Project: IEEE P802.15 Working Group for Wireless Personal Area Networks (WPANs)

Submission Title: [DS-UWB Responses to MB-OFDM-Voter NO Comments]

Date Submitted: [March 2004]

Abstract: [Response to NO voter comments and feedback regarding the DS-UWB (Merger #2) Proposal]

How Can The Rake Be So Small?

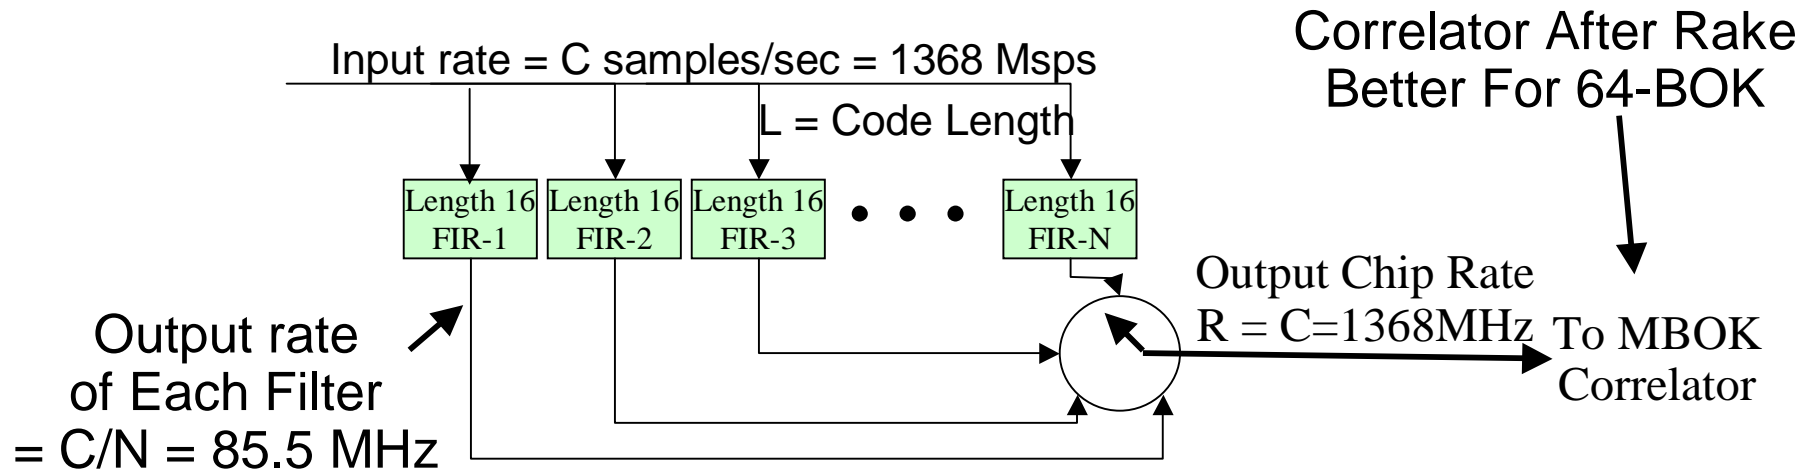
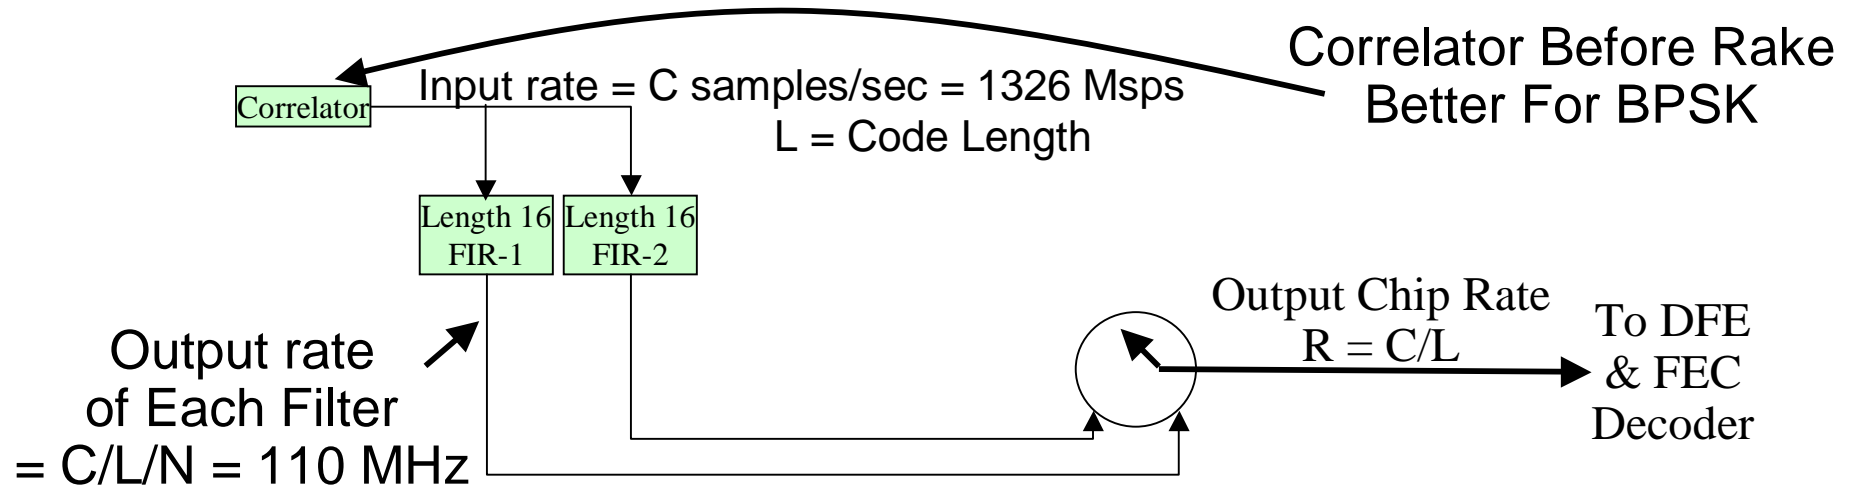
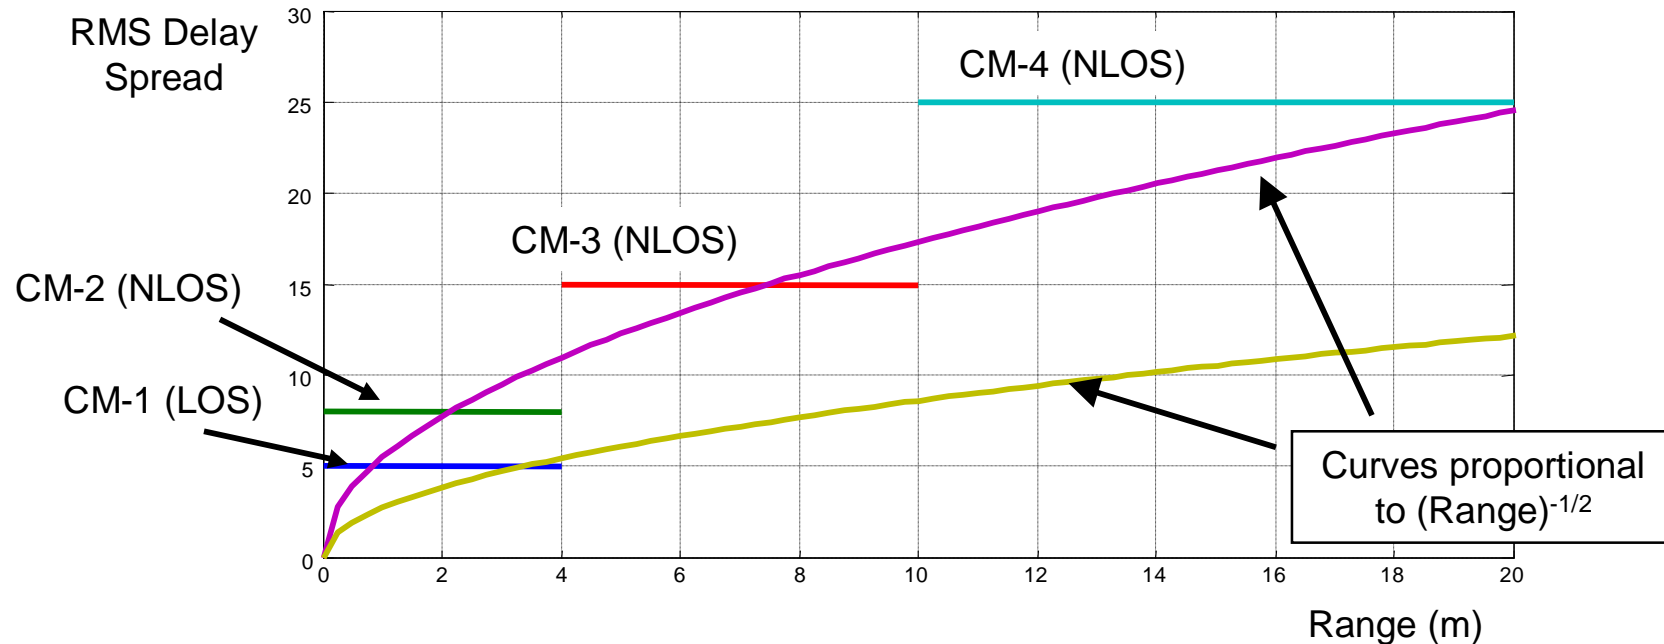
The MBOK proposal has provided performance results for only some of the modes. In addition, multiple receiver architectures have been assumed to address issues related to performance, complexity and the different modes. In reality, only one of the architectures can be chosen for an implementation. To better understand the proposal and the trade-offs associated with an implementation, we would like all results to be presented for a preferred architecture. To better understand the capabilities and limitation of the MBOK proposal, we would like answers to the following questions.

(a) Can you present all the requirements stated in the selection criterion document, namely the performance, complexity, power consumption, SOP and coexistence for a preferred receiver architecture?

- Gate count reduction is due to
 - Moving of code correlator prior to rake
 - Output rate is L Times lower
 - Reduces output rate by the code length
 - Replace 64-BOK with 2-BOK (BPSK)
- A/D Is 3 bits, not 4 bits

Parallel N=16 filters so each can run slower by a factor of 16
 $1368/16 = 85.5 \text{ MHz}$

Complexity = (16 multipliers) * (N=16 branches) * (800 gates per 4-bit mult)

= 205k Gates @ 85.5 MHz

Improved Proposal Is Based On 2 Parallel Branches, 3-bit A/D, Symbol Rate Output

Parallel N=2 filters so each can run slower by a factor of 2

$$1326/L/2 = 1326/6/2 = 110 \text{ MHz}$$

$$\text{Complexity} = (16 \text{ multipliers}) * (N=2 \text{ branches}) * (400 \text{ gates per 3-bit mult}) * (110 \text{ MHz})$$

$$= 26k \text{ Gates (including adders and overhead)}$$
